## 15B Failure Modes and Effects Analysis (FMEA)

The information in this appendix of the reference ABWR DCD, including all subsections, tables, and figures, is incorporated by reference with the following departures.

STD DEP T1 3.4-1 (Table 15B-3)

STD DEP 7.7-1 (Figure 15B-1)

Figure 15B-1 Simplified CRD System Process Flow Diagram

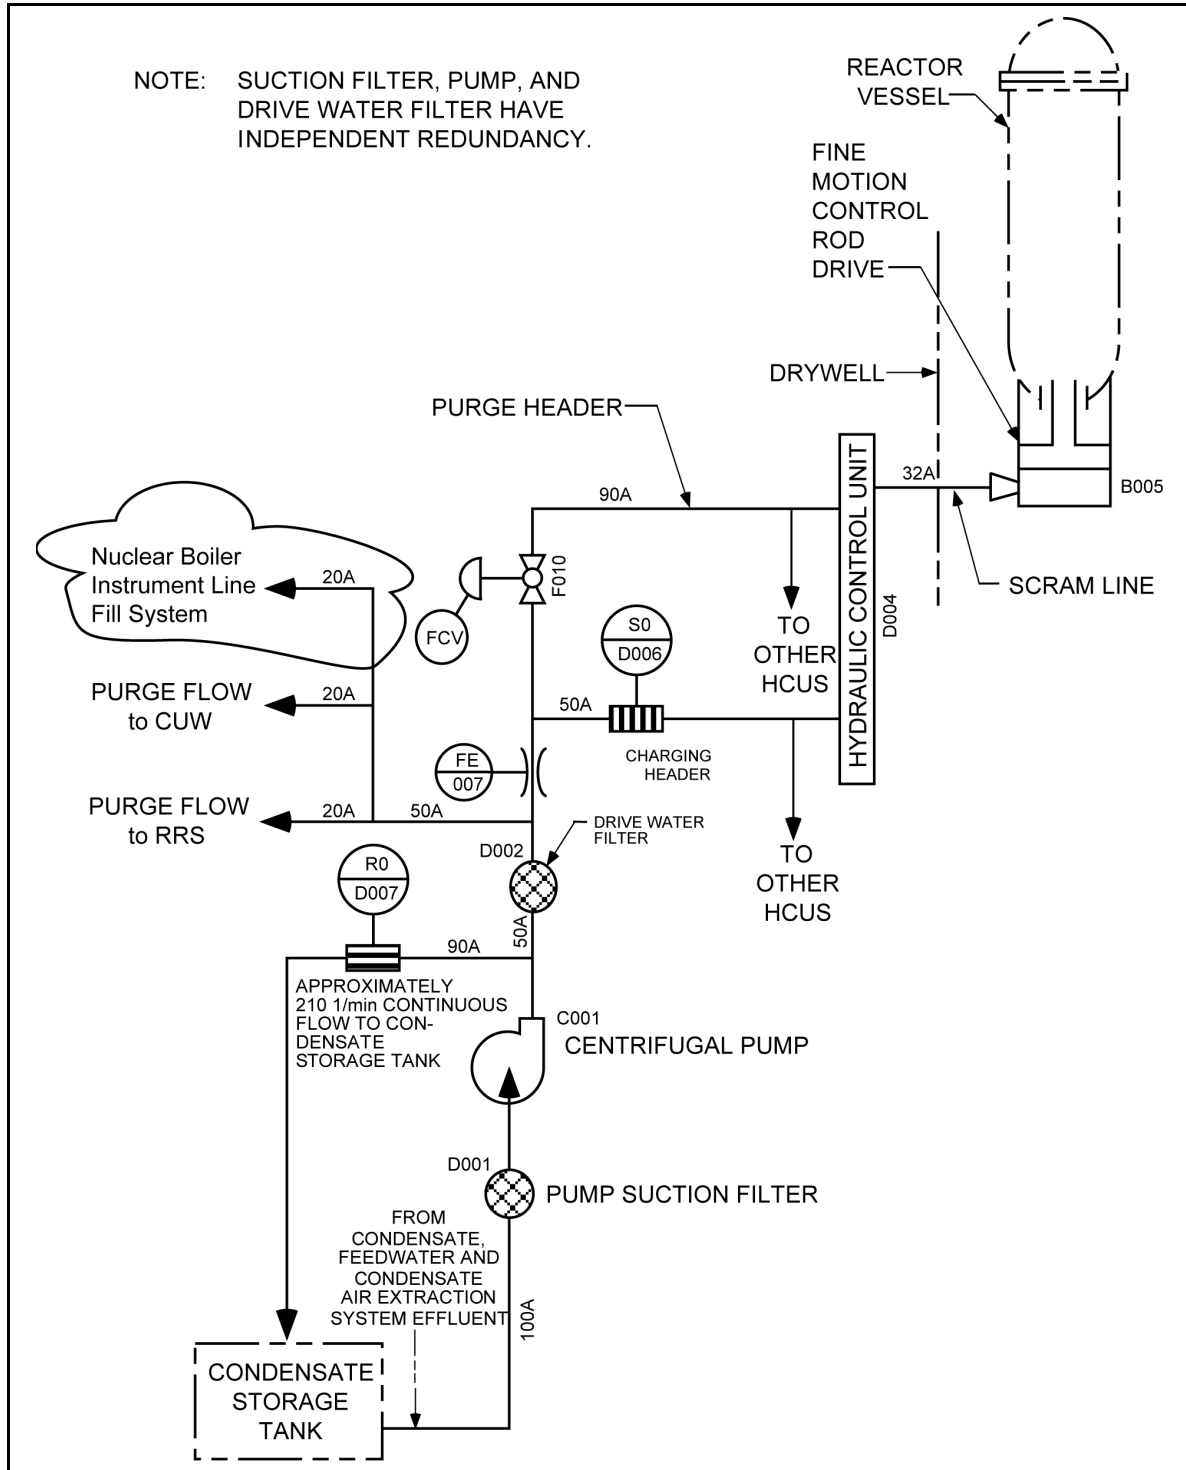
STD DEP 7.7-1

*A simplified CRD System process flow diagram is shown in Figure 15B-1. CRD System water is taken from the condensate, feedwater and condensate air extraction system, or Condensate Storage Tank (CST) through a suction filter by a centrifugal pump and discharged through a drive water filter to the HCU's. (During shutdown the CST is the primary source.) Each of these components is independently redundant and only one of each is in operation at any one time. A portion of the pump discharge flow is diverted through a minimum flow bypass line to the CST. The pumped water is directed to the HCU to provide hydraulic scram and to furnish purging to the drive. This system also provides purge water for the reactor internal pumps, nuclear boiler instrument lines, and the reactor water cleanup pumps.*
